digital	FIELD SERVICE TECHNICAL MANUAL				Option or Designator
	12 Bit <input checked="" type="checkbox"/>	16 Bit <input checked="" type="checkbox"/>	18 Bit <input type="checkbox"/>	36 Bit <input type="checkbox"/>	AD01

Title AD01 MULTIPLEXER F.E.T. Leakage				Tech Tip Number AD01-TT-1	
All Processor Applicability			Author R. Adams		Rev 0
8's	11's		Approval J. Blundell	Date 12/07/72	Cross Reference

Title AD01 Source Impedance Problems				Tech Tip Number AD01-TT-2	
All Processor Applicability			Author A. Thompson		Rev 0
8's	11's		Approval G. Chaisson	Date 12/08/72	Cross Reference

Title AD01A POWER SUPPLY PROBLEMS				Tech Tip Number AD01A-TT-1	
All Processor Applicability		Author G. Chaisson	Rev 0	Cross Reference	
8's		Approval W. Cummins	Date 07/31/72

GDI PRINT A6

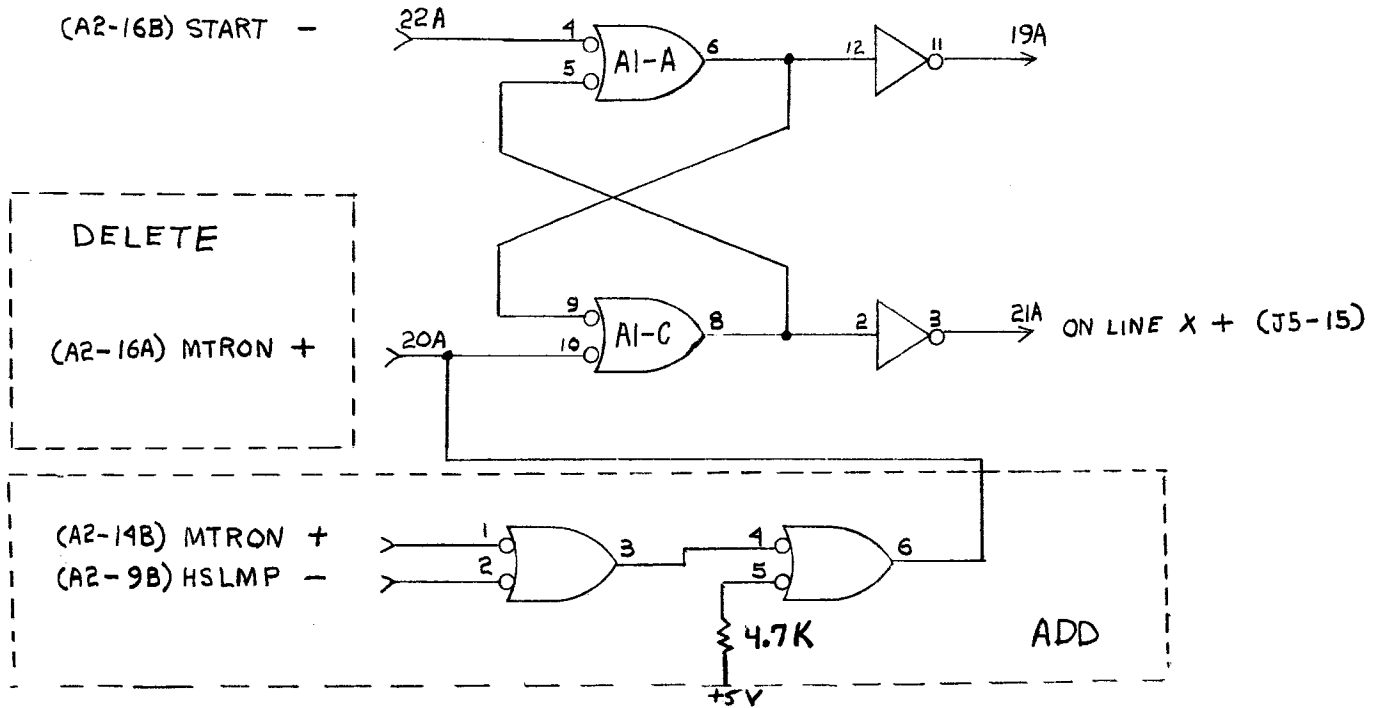
SOLUTION: The only way to correct the problem is to OR the Hopper Empty signal with MTRON + and use the resultant signal for resetting ON LINEX: this can only be accomplished by adding an external component to the existing GDI logic.

The following diagrams will explain the exact nature of the modification.

See drawing, page C.

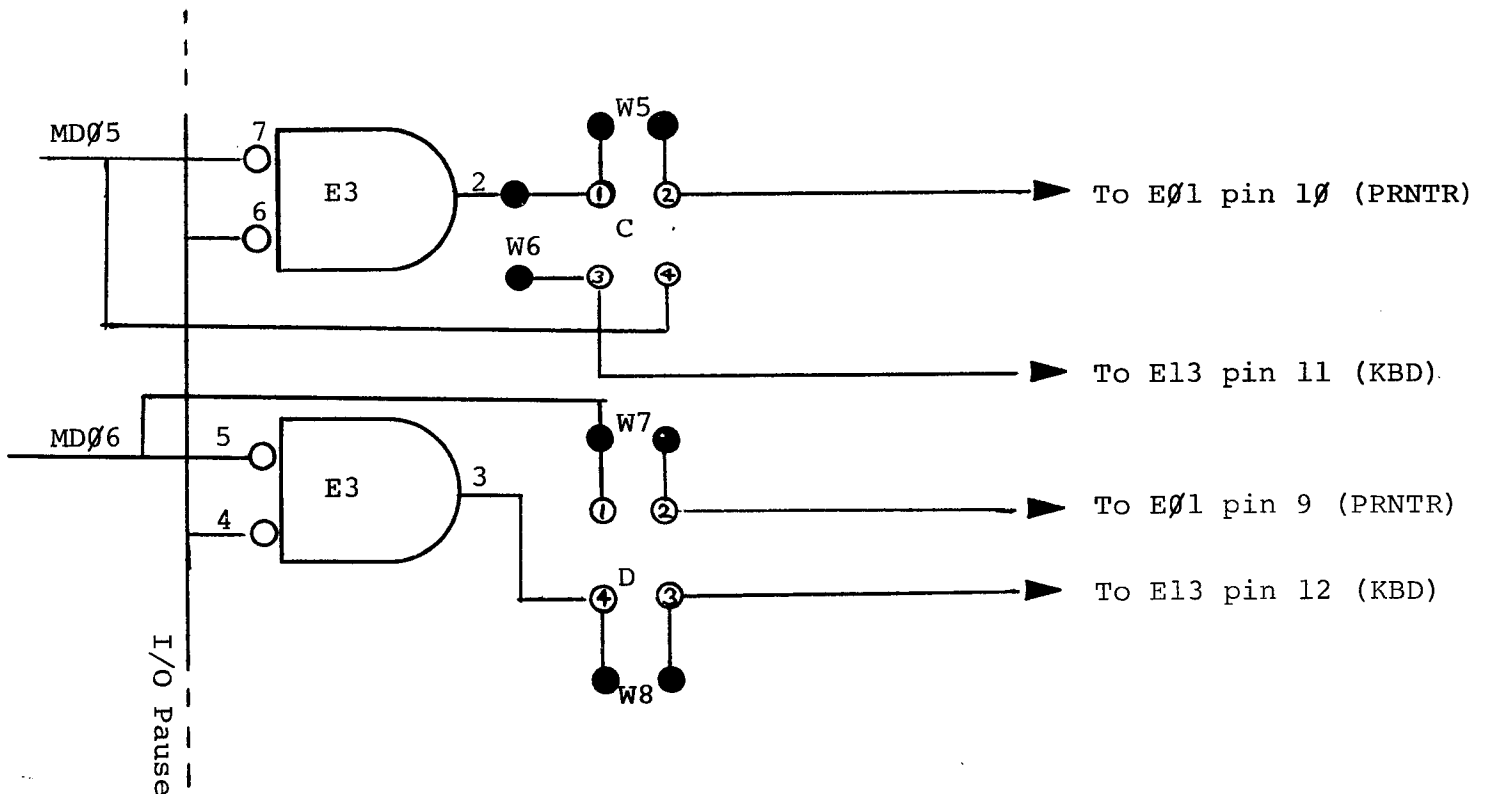
The fault symptom will typically be either wrong sense of bits 5 or 6 in the decoded IOT, or MD bit 6 always constant on the omnibus.

The same mistakes have been carried over into the LS8E (M8342) control. The drawing below also applies exactly to the C.S.Rev.0 of that board.

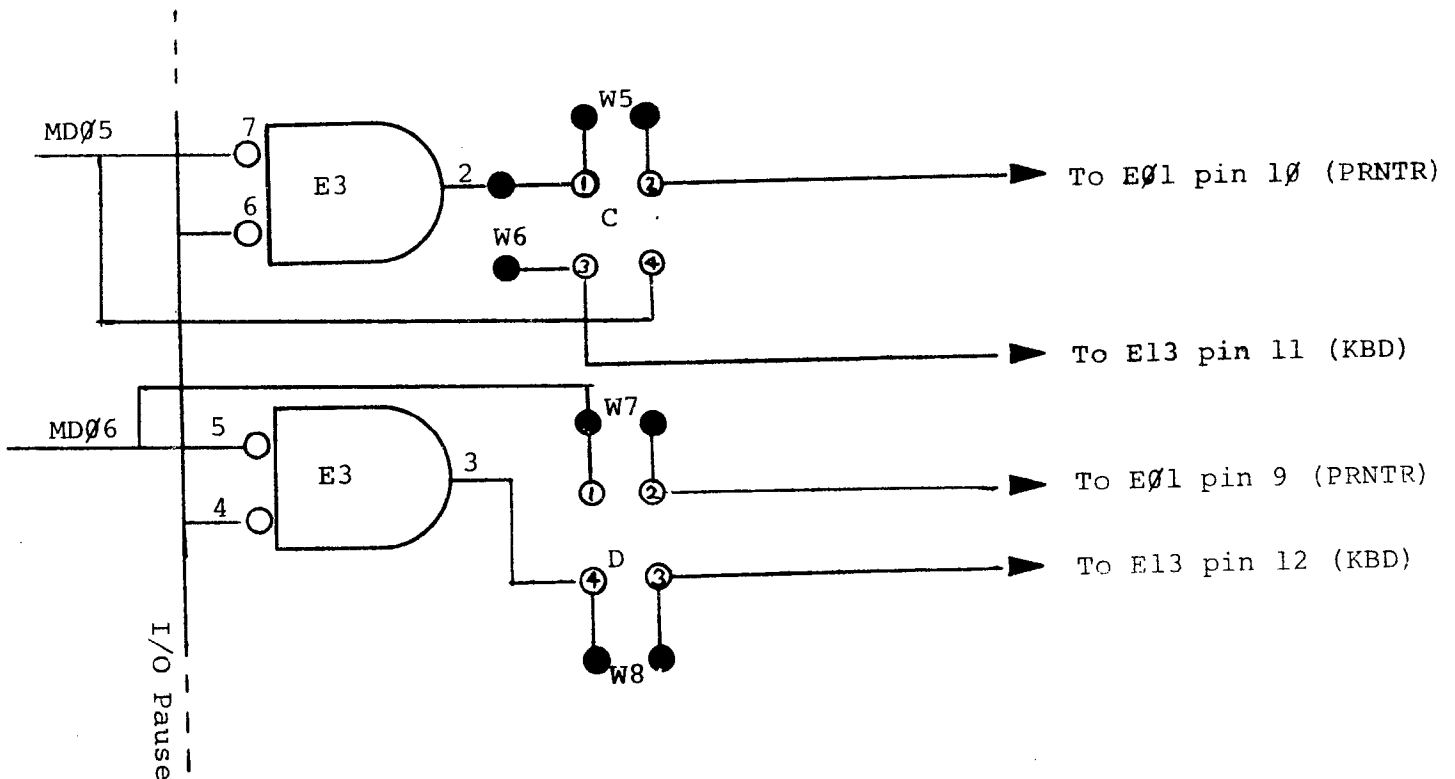
The fault symptom will typically be either wrong sense of bits 5 or 6 in the decoded IOT, or MD bit 6 always constant on the omnibus.

The same mistakes have been carried over into the LS8E (M8342) control. The drawing below also applies exactly to the C.S. Rev. 0 of that board.

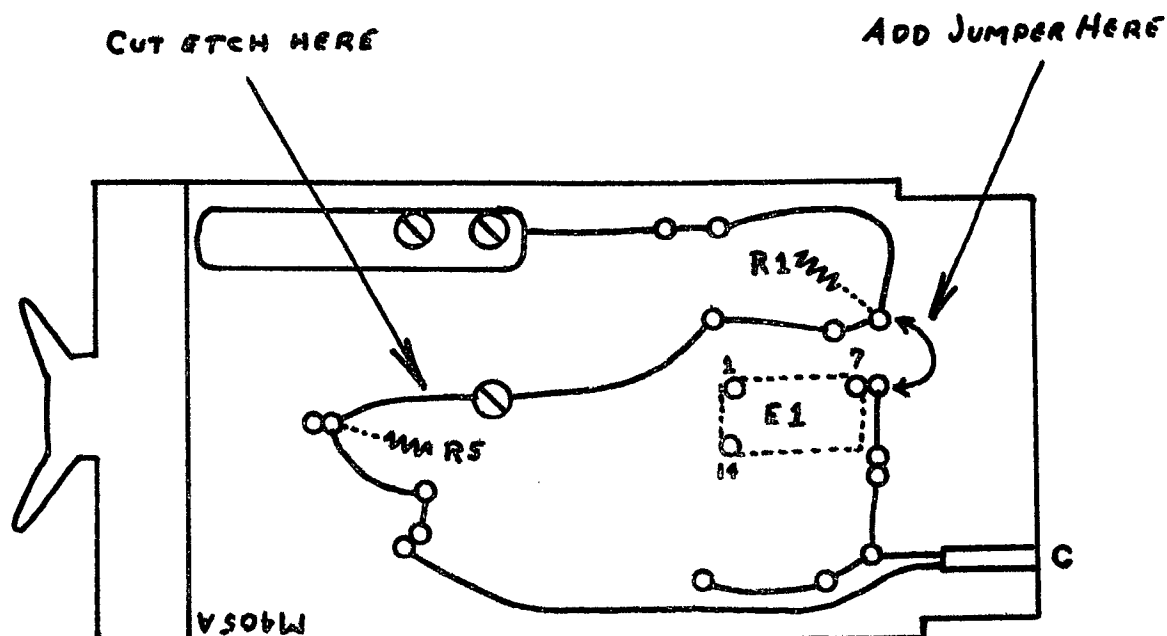
If an M405B is not available you may install the ECO yourself as follows: Looking at the etch side of the M405A (Handle **UP**), cut the etch between the bottom left shield screw and R5. Solder a piece of insulated wire from Pin 7 of E1 to the ground side of R1.

The accompanying sketch illustrates the ground path and the alteration points.

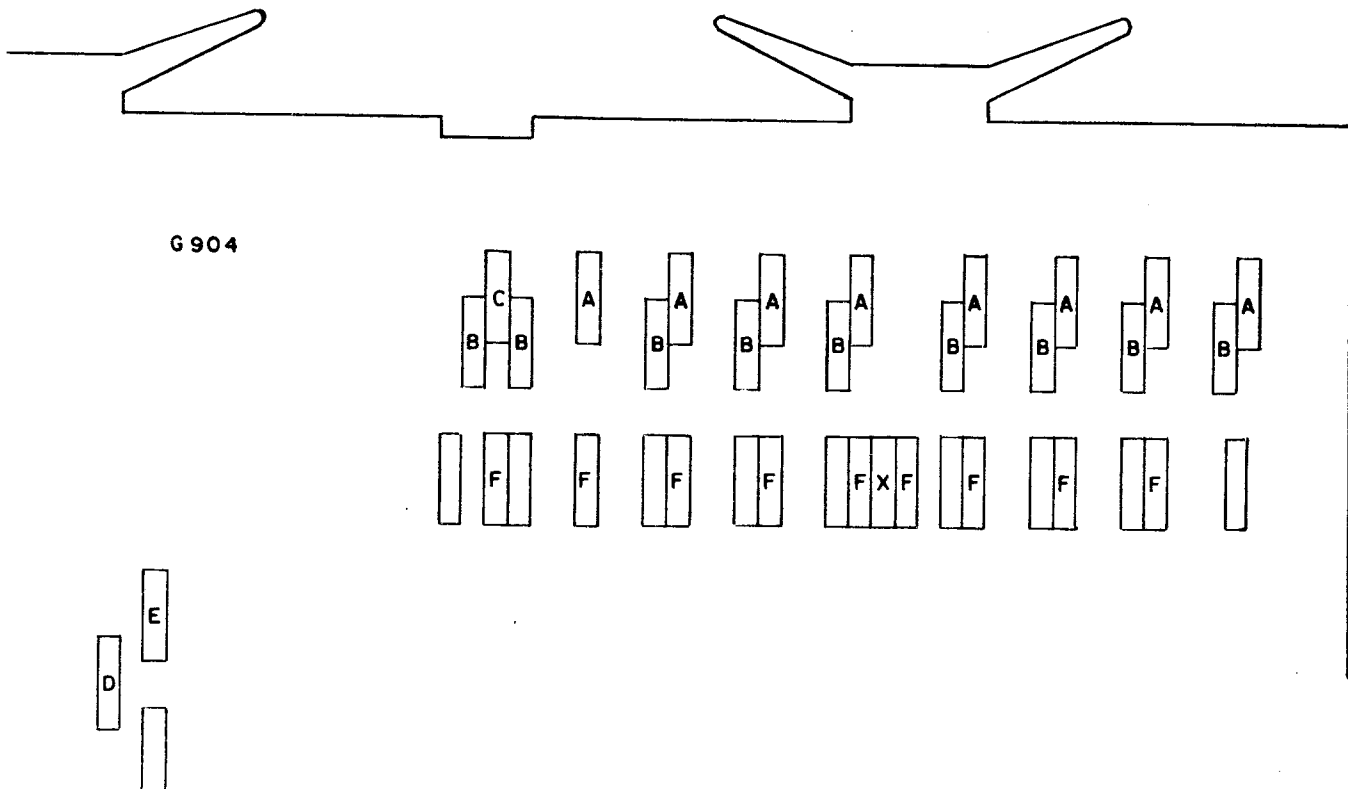
1. Change eight (8) 12K ohm resistors ("A" in drawing below) to 100K ohm, 1/4 W, 5% (DEC Part #13-2466).
2. Change nine (9) 3K and 1K ohm resistors (B) to 100 UF capacitors (DEC #10-00016).
3. Change 3.9K ohm (or may be 7.5K) resistor (C) to 27K ohm, 1/4W (DEC #13-5346).
4. Replace the 2.2K ohm resistor (D) with a jumper wire.
5. Replace the ZENER diode (E) with a 1N750A ZENER (DEC #11-00124).
6. Remove nine (9) .01UF capacitors (F) from the card; there should be only one (1) .01UF remaining on the card, (X).

FIGURE 1

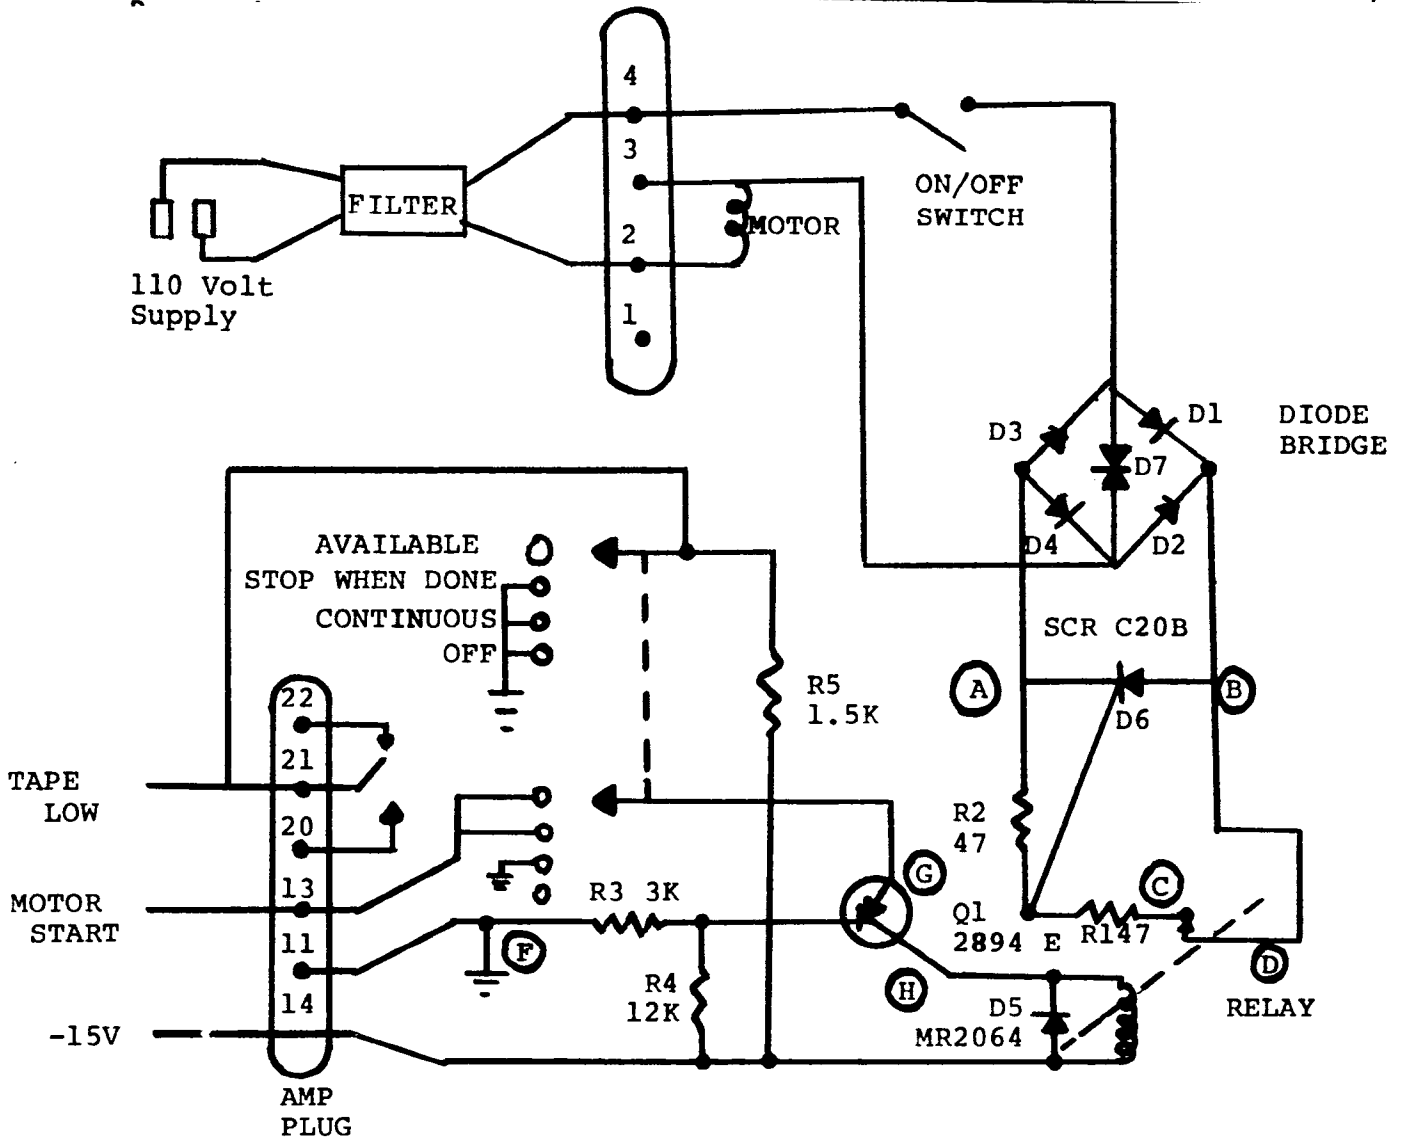
Using Figure 1, if the punch does not turn on properly, you can find the trouble using a jumper wire.
